**ADDENDUM #1**

**IFB 19-154 Dispatch and Alarm HVAC Unit Replacements Re-Bid**

**Mechanical Demo / New Work Plans**  
**Renovations & Additions**  
**Wentzville Alarm & Dispatch Facility**  
**St. Charles County Government**  
1605 Wentzville Parkway Wentzville, MO 63381

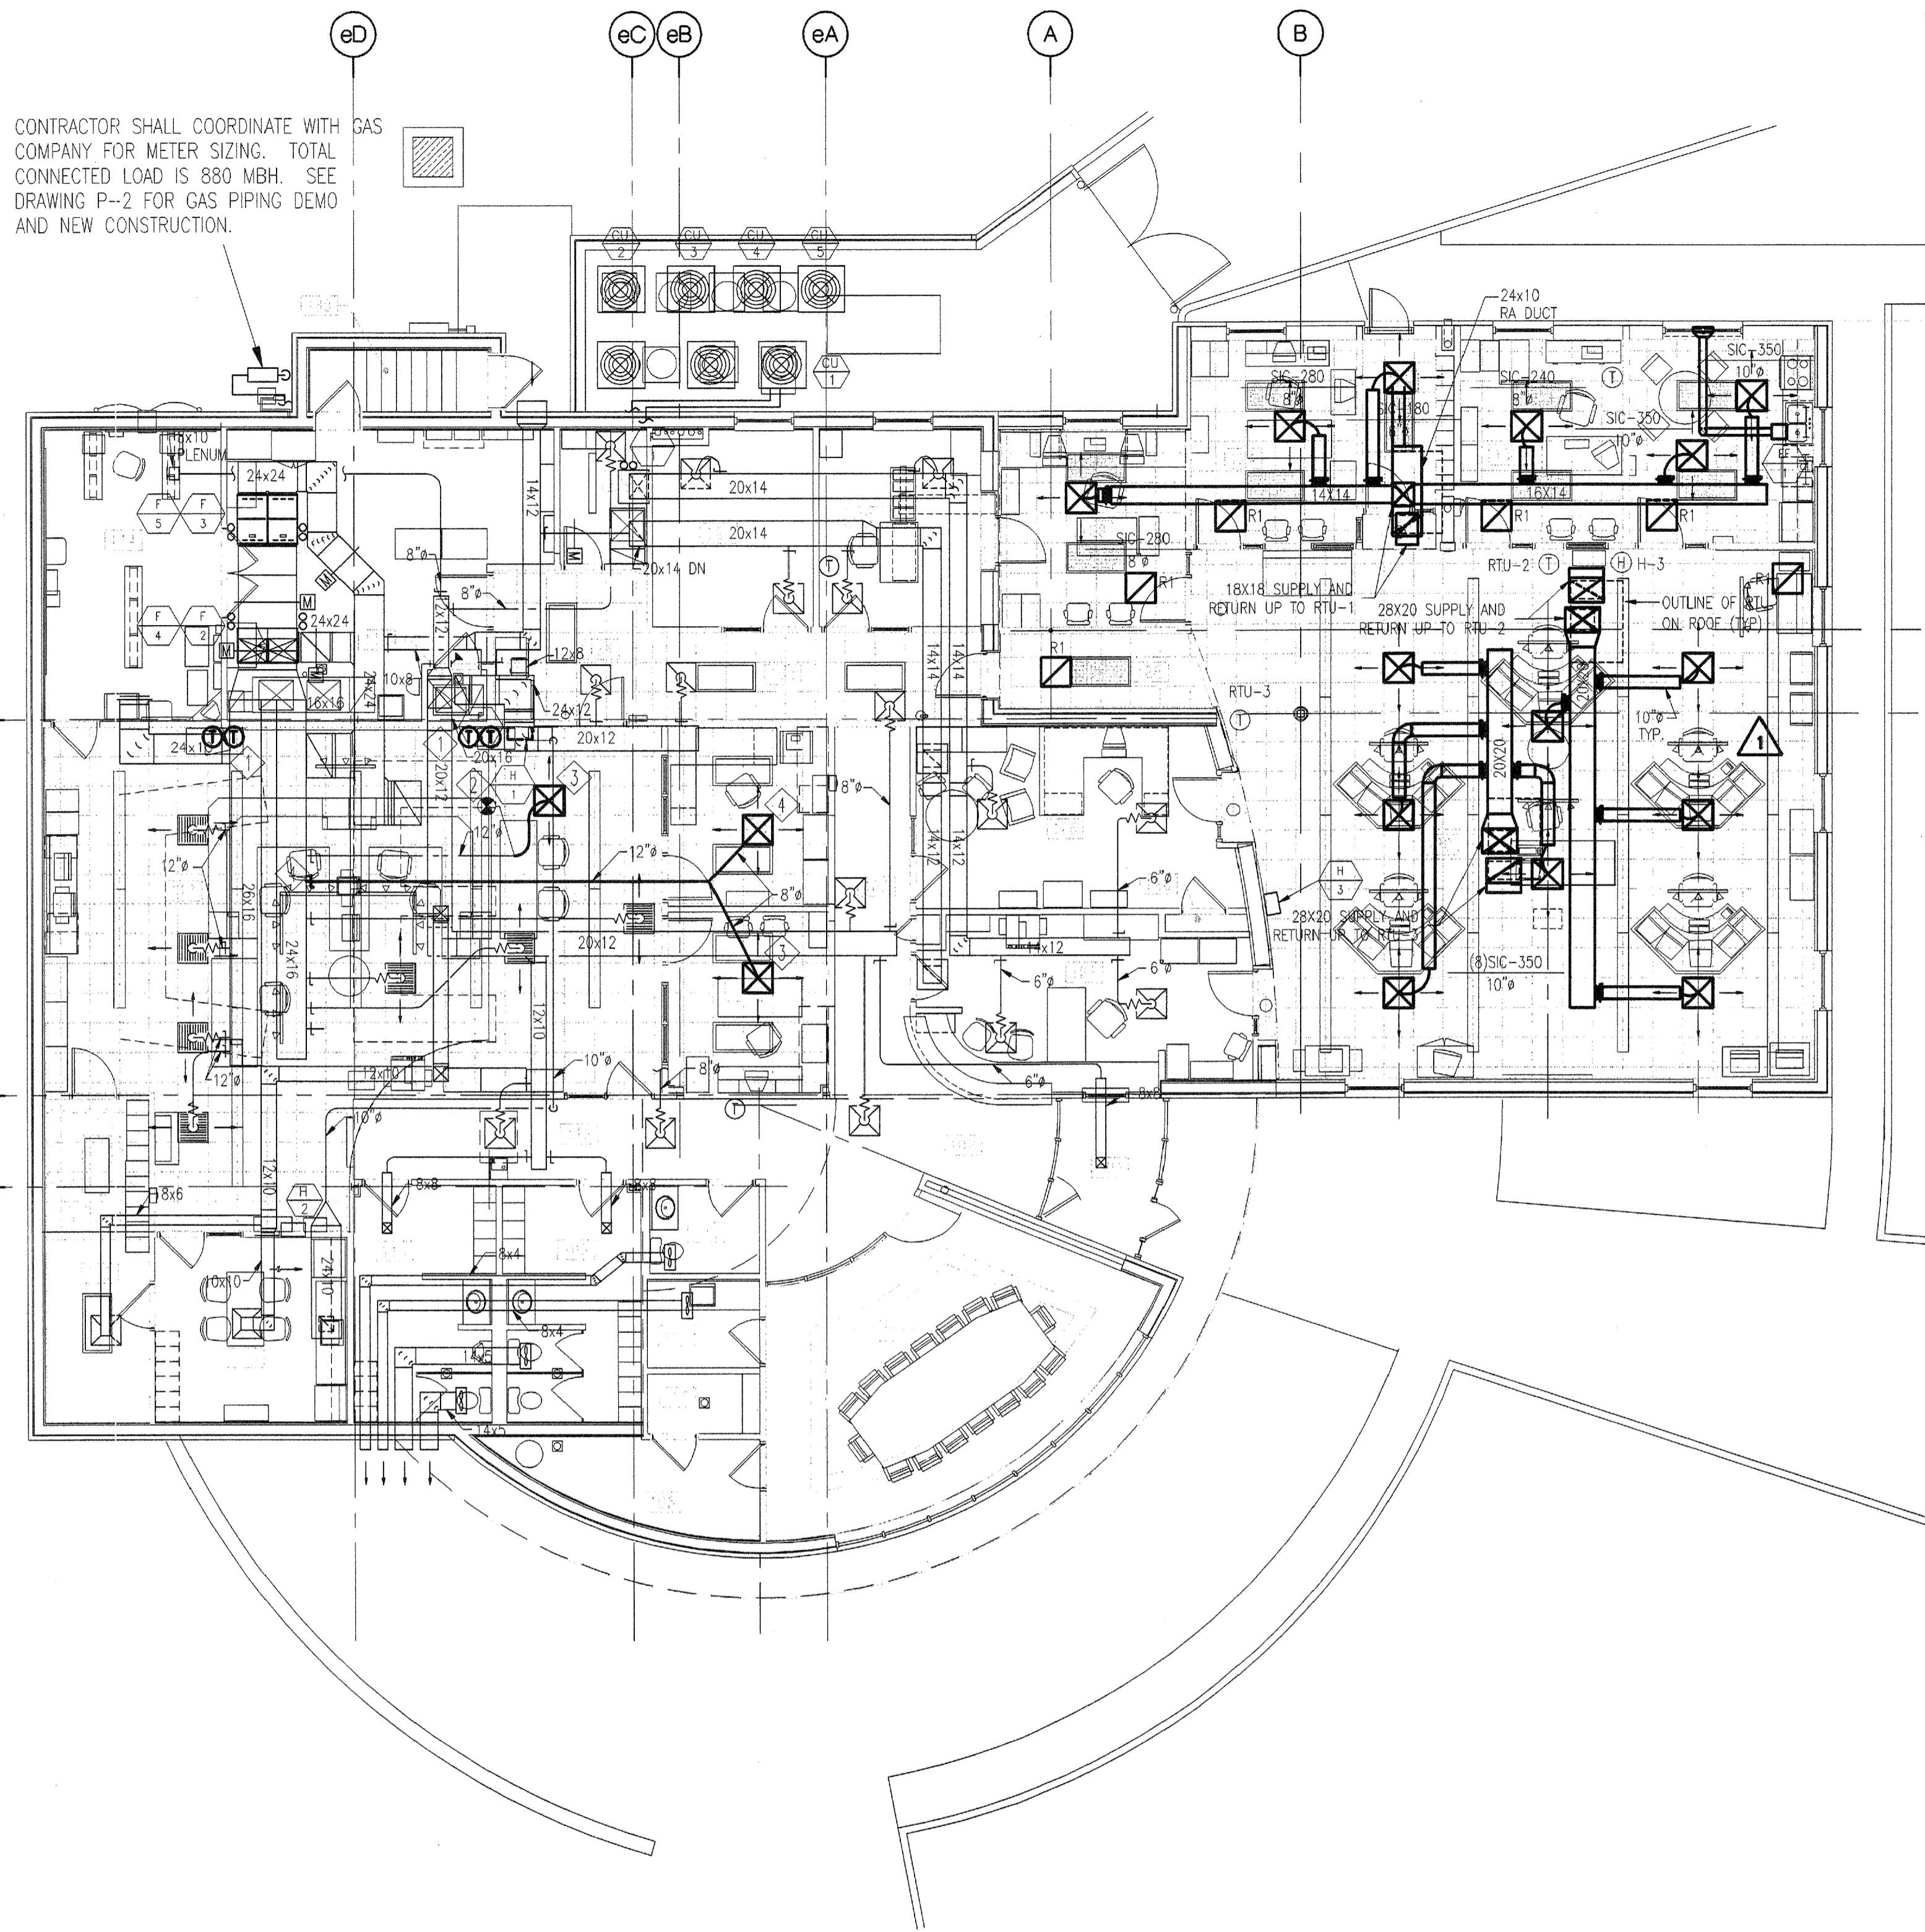
Mechanical floor plan is being added with this addendum.
